Agenda Title: Approval of Change Order #9 with DN Tanks, LLC. for the Carter Hill Prestressed Concrete Tank and Seismic Upgrades Project

Contract Change Order (CCO) No. 9

Project: <u>Carter Hill Prestressed Concrete Tank & Seismic Upgrades Project</u>	Owner: <u>Coastside County Water District (CCWD)</u>	Owner's Contract No.: <u>CIP Number 21-07</u>
Contractor: <u>DN Tanks, LLC</u>		Date of Contract: <u>July 21, 2024</u>

Contract Change Order (CCO) #9 Summary
Carter Hill Prestressed Concrete Tank and Seismic Upgrades Project
 Coastside County Water District
 Half Moon Bay, California

From: Xu, Arthur <Arthur.Xu@hdrinc.com>
Sent: Monday, April 13, 2026 10:25 AM
To: Sotomayor, Ulysses; Jackson Lo; Josh Kimbrell
Cc: Hayden Hansen; Esbah, Chris; Katus, Michael; Arredondo, David
Subject: RE: RFI 59.0 Steel Control Valve Piping Conflict with Manway Location Response

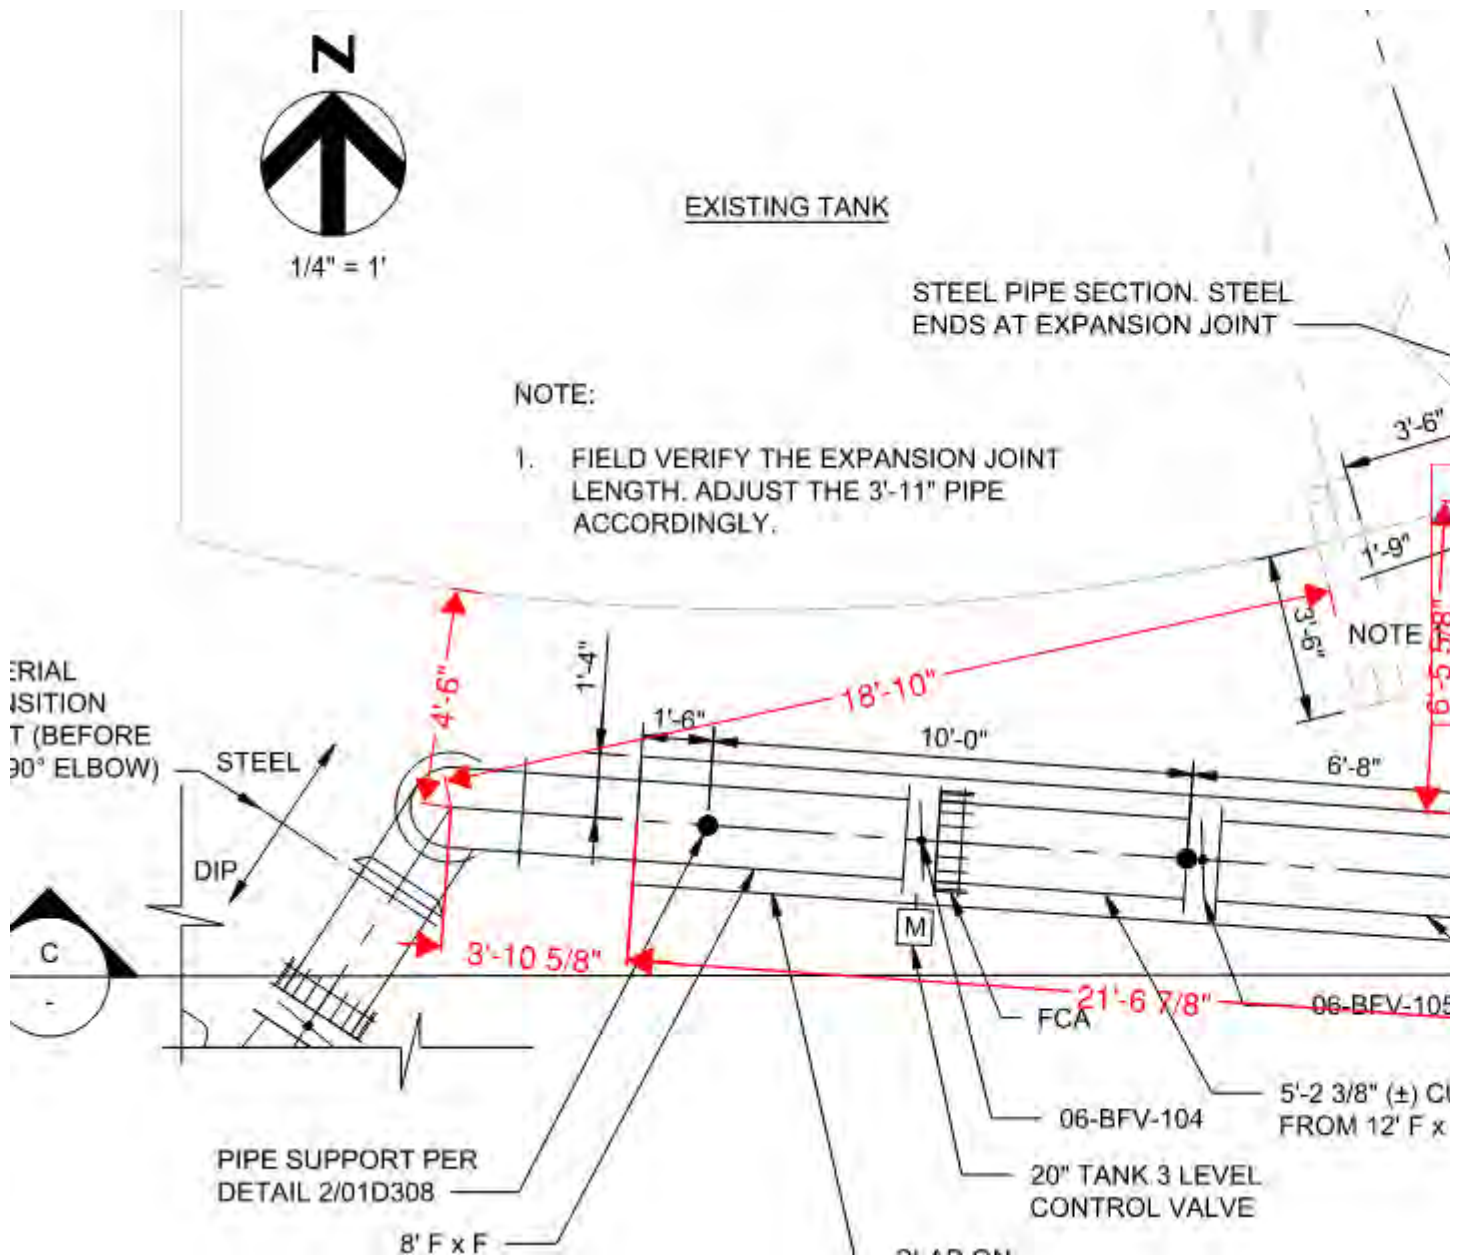
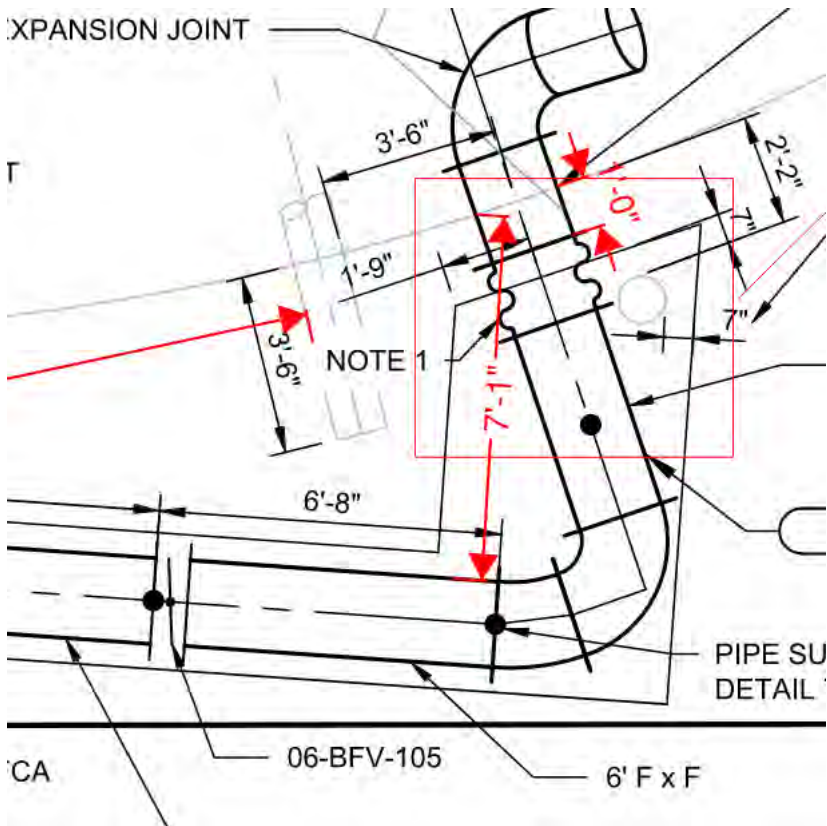
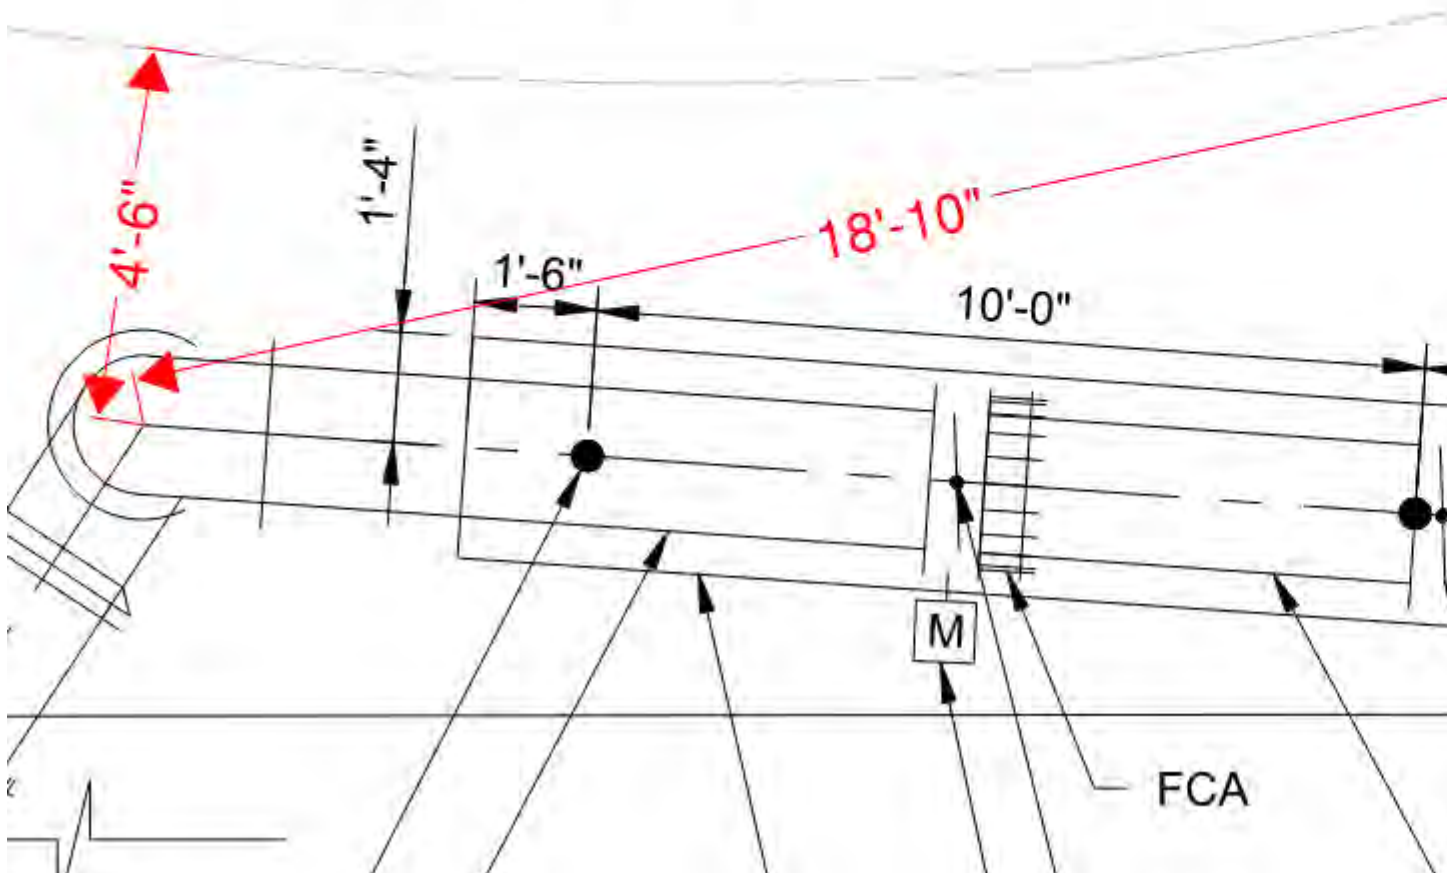
Andreini is not really sure about the angle for the concrete pad. They are asking for that dimension shown in purple, but the bigger question is if the angle of the pipe changed at all per prior revisions?

Could you please confirm this in the next hour – Pad is planned to be poured today at noon.

What HDR prepared is the minimum footprint required for the pad. If the pad is slightly larger than that, it's acceptable.

You can measure off of the updated drawing. IN the last version, CAD has caught a small angle off (0.4 degree). It's been corrected.

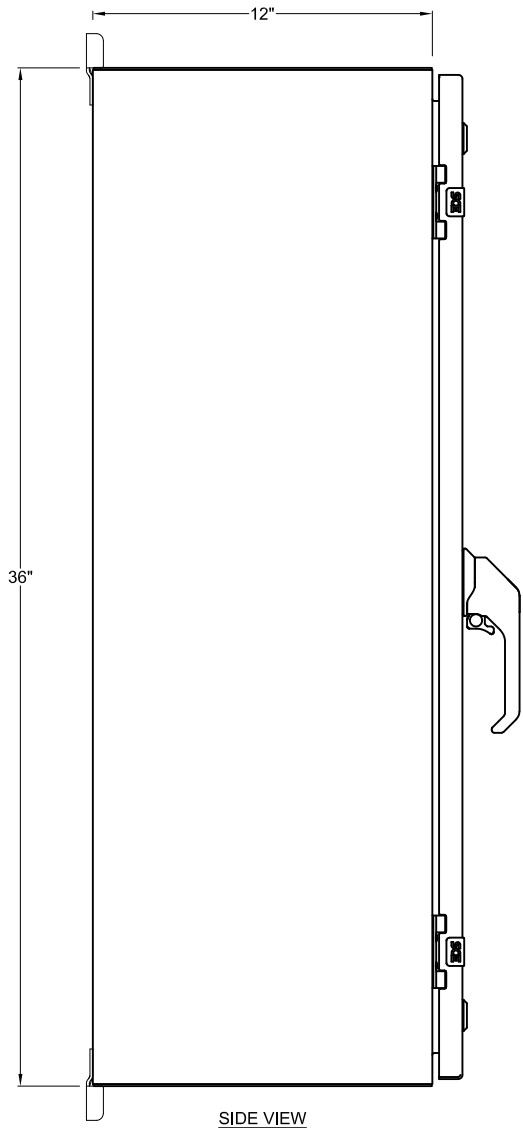
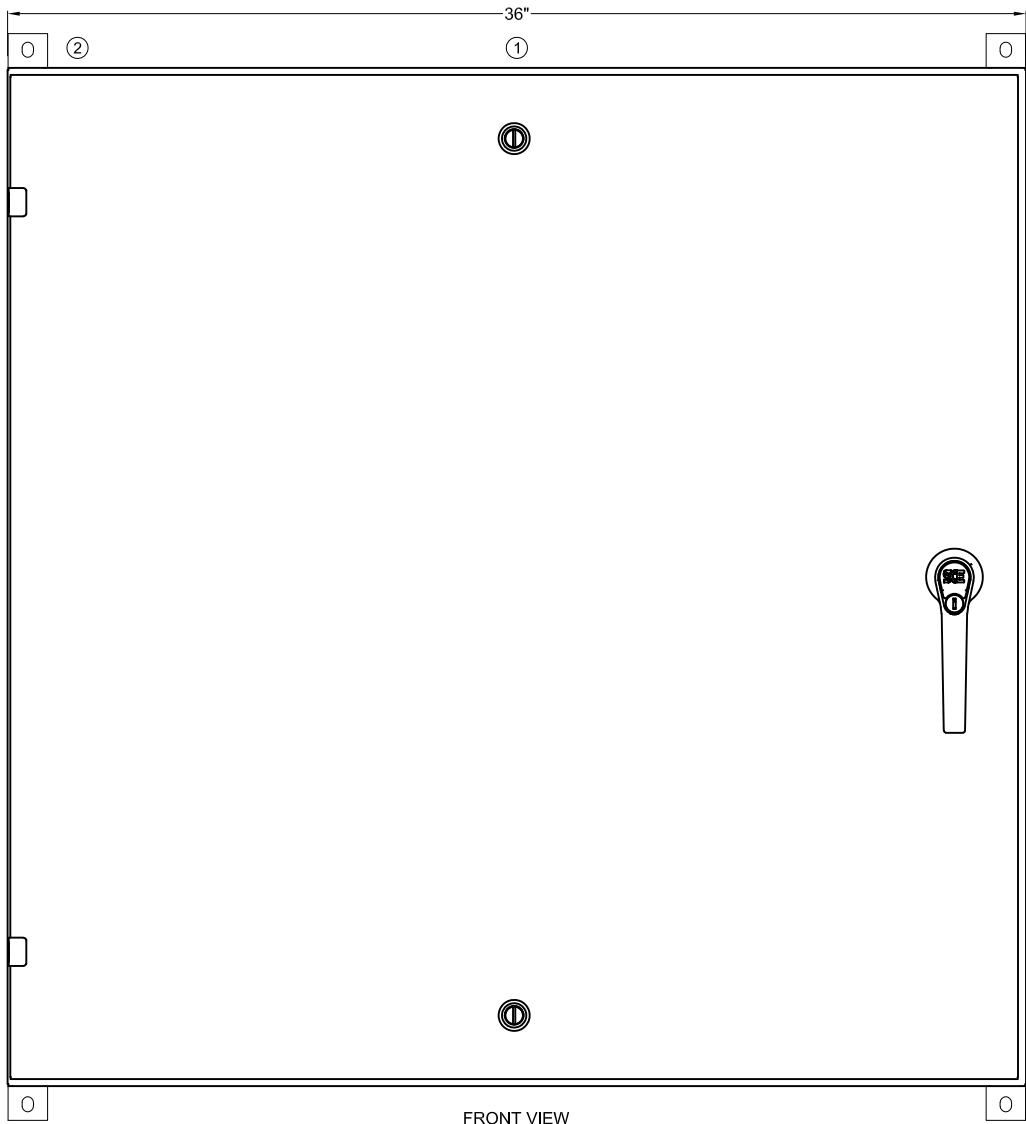
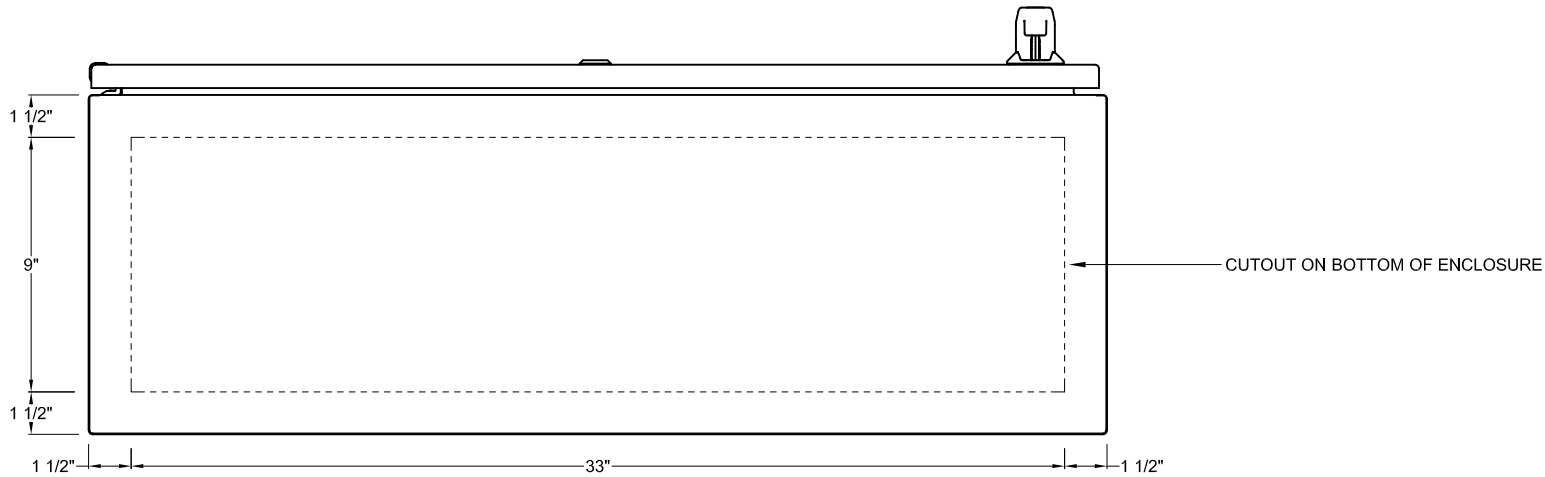
Description	Sub. Cost (SS Cabinet)	Credit for Aluminum Cabinet	Total Upgrade Cost	Owner Cost Share (50%)	Schedule Impact	Comments
Sample Tap Cabinet	\$4,900.43	-\$1,000.00	\$3,900.43	\$1,950.21	0.00	(1) 316SS Stainless Steel Enclosure, 36x36x12, custom modification/rectangular bottom cutout.
